## 9.4 Air Conditioning, Heating, Cooling and Ventilating Systems

The information in this section of the reference ABWR DCD, including all subsections, tables, and figures is incorporated by reference with the following departures and supplements.

Figure 9.4-2c Electrical Building HVAC System Diagram  
Turbine Building Electrical Equipment Areas (EEA) HVAC System Diagram

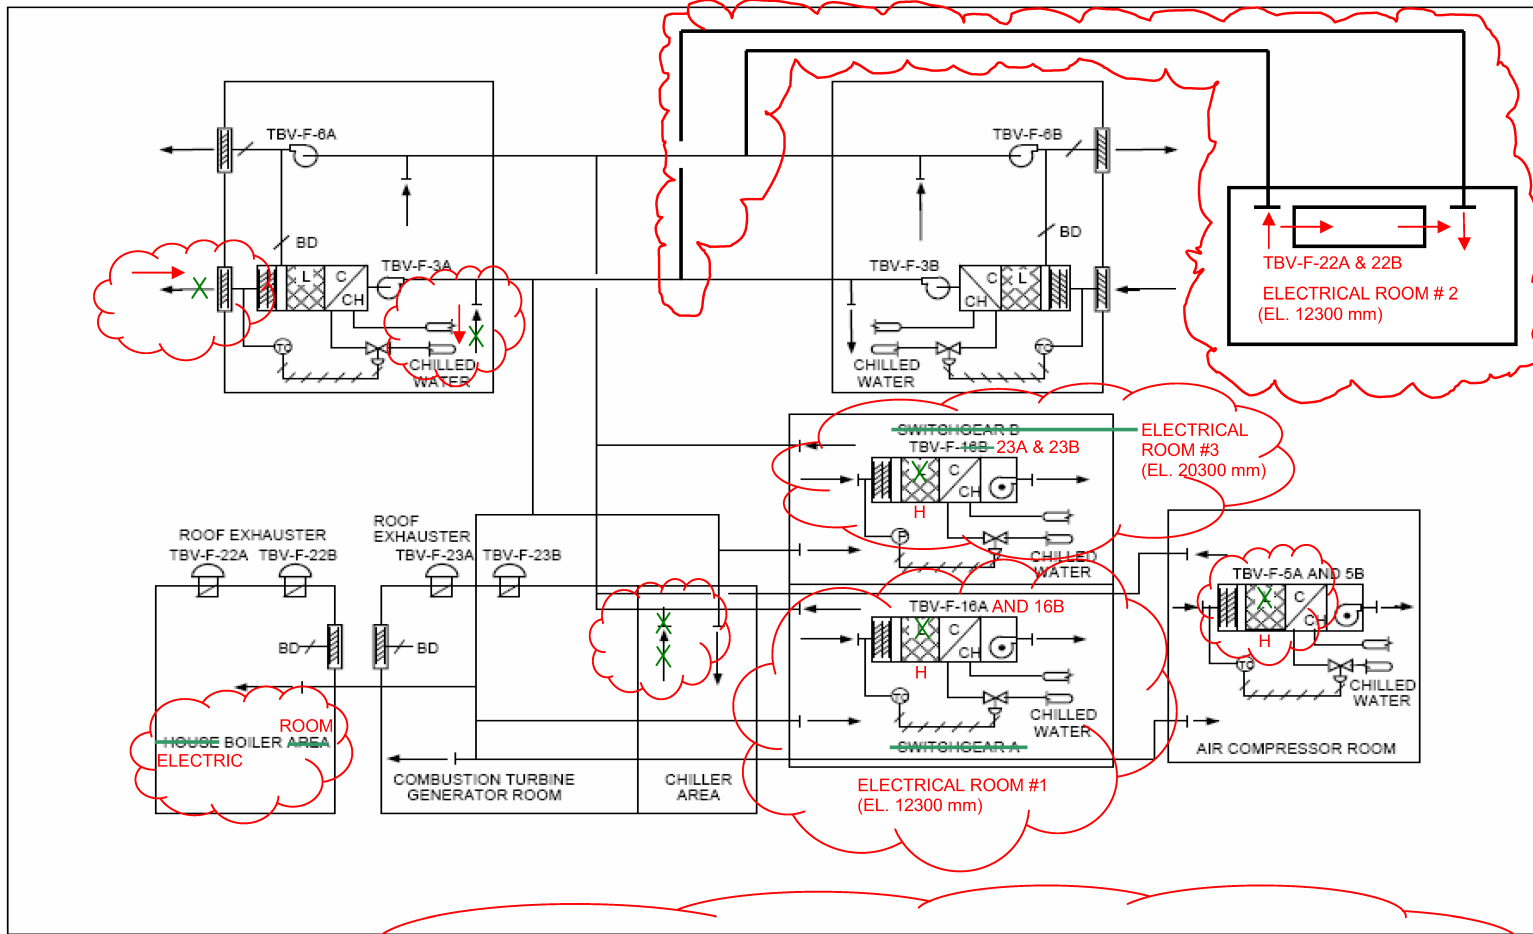
STD DEP 9.4-4 (Tables 9.4-3, 9.4-5, 9.4-5a, 9.4-5b, 9.4-5c, and 9.4-5d), (Figures 9.4-2a, 9.4-2b Sheet 2, and 9.4-2c)

STD DEP 9.4-4

#### 9.4.4.2.2 ~~E/B~~ EEA HVAC General Description

The ~~E/B~~ EEA HVAC schematic diagram is shown on Figure 9.4-2c.

The air supply fan draws outside air through louvers, control dampers, low efficiency filters, and chilled water coils, and discharges air directly into the ~~switchgear~~ electrical rooms, chiller, combustion turbine generator, ~~house~~ electric boiler room and air compressor rooms. Return air Ductwork ductwork and ~~bypass dampers~~ are is provided to allow recirculation of air from the ~~switchgear~~ electrical rooms and ~~chiller rooms~~ air compressor room.
